Comment	Response
<p>Line 15–20</p> <p>You state that “the combined ‘Q + LAI’ can be used as a proxy to predict AET rates.” This is an important claim but needs further qualification. While your results suggest that LAI contributes to improved AET estimates, it is not fully demonstrated that this proxy relationship holds across climatic variability or land use types. You may consider referencing doi: [10.1016/j.scitotenv.2020.143792], which evaluates how dynamic LULC influences surface runoff and can affect AET estimates as well.</p>	<p>The study covers the analysis of two different meteorological forcing data sets, three calibration approaches, and 20 best-fit parameter sets per modeling approach. Therefore, simulation results are extensive. Moreover, the spatial resolution of the satellite-based LAI and AET data is 250x250 m and 0.0833°x0.0833° (ca. 9x9 km). Comparing satellite-based and simulated LAI and AET, the evaluation is carried out at the subbasin scale. To summarize the evaluation, we focus on a subbasin- and catchment scale evaluation with area-weighted performance criteria (here Kling-Gupta efficiency). At these scales, a clear improvement between the approaches Q-only

**Figure 1** Comparison of monitored AET (AET-obs, black line) to multiple satellite-based and reanalysis AET products at the forested footprint for different temporal scales a) daily, b) 8-daily sum, and c) monthly sum. Please note the varying y-axis scales for readability.

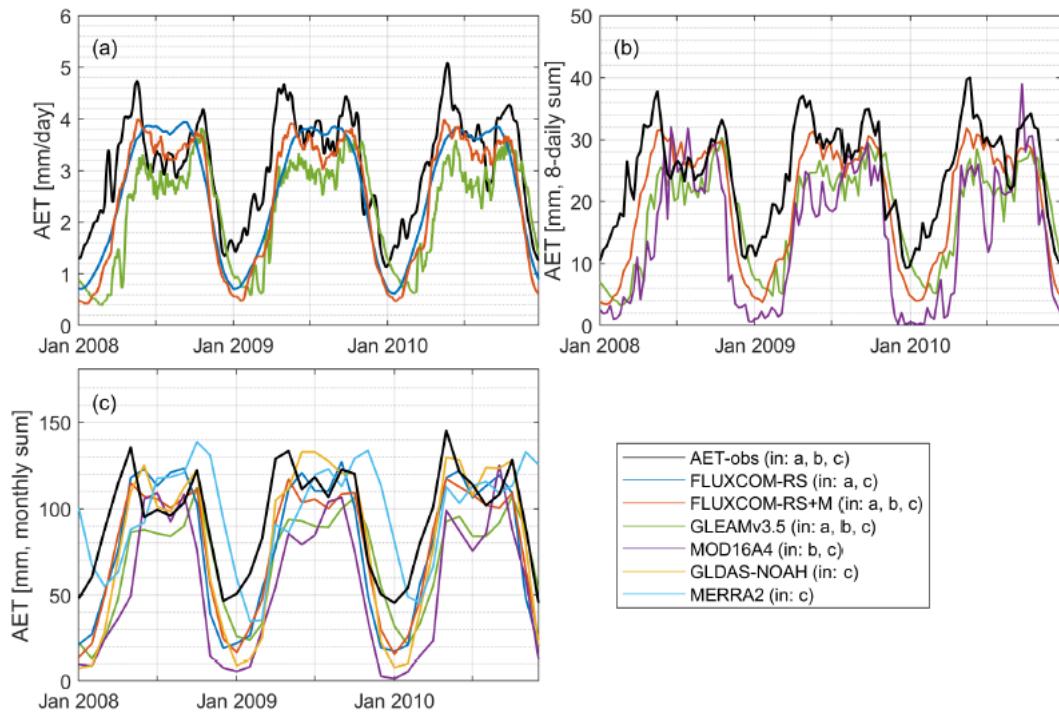
<p>Throughout, there is a lack of critical reflection on the limitations of remote sensing products used for LAI and AET. While GLASS-LAI and FLUXCOM are high-quality datasets, they carry uncertainties, especially in tropical canopies. A brief paragraph discussing these limitations would strengthen the credibility of your validation approach.</p>	<p>We thank the reviewer for this important suggestion. This referee comment aligns with the feedback from Referee #2 in [<a href="https://doi.org/10.5194/egusphere-2025-3836-RC2">https://doi.org/10.5194/egusphere-2025-3836-RC2</a>]. We therefore respond similar to both referee comments:</p> <p>GLASS-LAI and FLUXCOM-AET are both widely used and are considered high quality. In tropical regions, remote sensing can be influenced due to cloud cover. The cloud influence is particularly prominent in MODIS-derived LAI products. Therefore, we used the more robust GLASS-LAI product. The FLUXCOM product integrated eddy covariance observations, yet these are unevenly distributed across climate zones.</p> <p>As mentioned before, a comparison of GLASS-LAI to modeled LAI with SWAT-T can be found in Merk et al. (2024). We tested the FLUXCOM-AET accordingly before its application in this study, see figure below. Given this promising validation, the products still carry inherent uncertainties.</p> <p>We have added a paragraph discussing the limitations and uncertainties with GLASS-LAI and FLUXCOM-AET.</p> <p>We now explicitly acknowledge that these uncertainties may influence the representation of LAI and AET at the sub-basin scale. Including this discussion clarifies the scope of our validation and improves transparency regarding data limitations.</p> <p>The following paragraph is added to the manuscript after line 502:</p> <p><i>The application of satellite-based GLASS-LAI and FLUXCOM-AET data for a tropical catchment like the Bétérrou Catchment carries uncertainties. Generally, GLASS-LAI and FLUXCOM-AET are both widely used and are considered high quality. Yet, satellite-based datasets in tropical regions can be subject to</i></p>

<p><i>cloud contamination and reflectance noise (Viovy et al., 1992; Atkinson et al., 2012) or the lack of observation networks for validation (Weerasinghe et al., 2020). For the Bétérou region, the GLASS-LAI dataset shows promising applicability when compared to monitored data (Merk et al., 2024). FLUXCOM-AET has been extensively validated against eddy covariance (EC) measurements across a wide range of climatic conditions, supporting its general reliability (Jung et al., 2019). This study relies on a pointwise validation of FLUXCOM-AET and GLASS-LAI. While this approach does not fully capture spatial heterogeneity or all sources of uncertainty, it provides a consistent and pragmatic basis for model evaluation in data-scarce tropical regions. This approach ensures that the validation framework remains robust and fit for purpose.</i></p>
<p>Finally, regarding language and terminology throughout the manuscript, I believe that phrases such as “to guarantee convergence,” “mimics well,” and “modeling potential” could be rephrased to enhance precision. For instance, “the model performance plateaus after 12 iterations” is preferable to “to guarantee convergence.” Similarly, instead of “mimics well,” you could say “closely reproduces.”</p>	<p>We highly appreciate the reviewer’s feedback on language and wording. We screened through the manuscript and adjusted poor phrasing to improve the readability.</p>

**Figure 2** Average soil moisture for the 14 subbasins (letters a-n) for model forcing with obs-data.

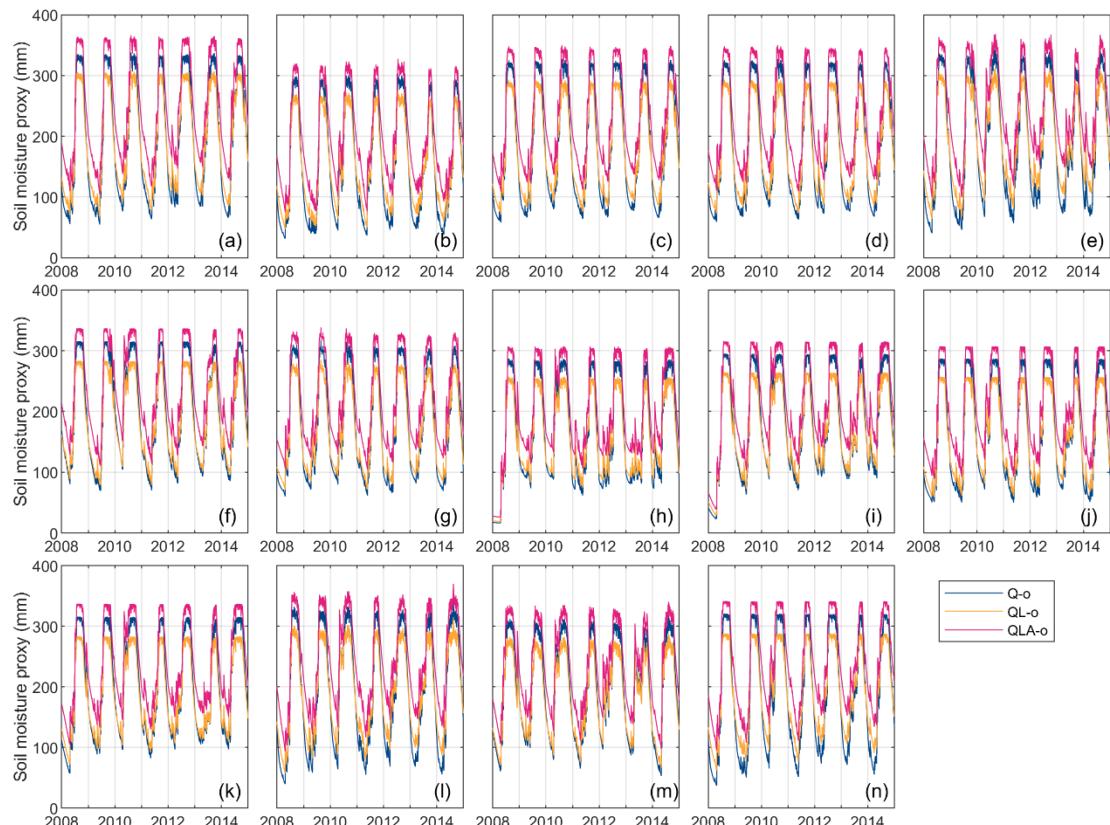
<p>Lines 361–375</p> <p>The seasonal patterns of AET are well captured in the model, particularly the mid-season dip. However, your explanation that this dip is “due to lack of LAI representation” in Q-only is somewhat superficial. Could the effect also arise from misrepresented soil moisture dynamics or canopy interception?</p>	<p>We also evaluated the soil moisture response for the simulation of the current climate conditions, see for example Figure 2. The different modeling strategies simulate similar patterns of soil moisture. More precisely, the soil moisture dynamics are similar among the strategies since all of them are calibrated against discharge which has the most influence on soil moisture in the SWAT/SWAT-T model.</p> <p>Canopy interception <math>E_{can}</math> is linked to LAI in SWAT/SWAT-T with the formula:</p> $E_{can} = I_{max} * \frac{LAI}{LAI_{max}}$ <p>Where <math>I_{max}</math> is the maximum canopy interception (model parameter, CAN_MX), LAI is the computed LAI, and <math>LAI_{max}</math> is the maximum LAI (model parameter, BLAI). Therefore, inappropriate modeling of LAI (e.g, very small values for LAI) influences canopy interception.</p> <p>Given the soil moisture is similar among the strategies and canopy interception is linked to LAI, we concluded that the “AET-dip” representation is strongly due to limits in LAI modeling.</p>
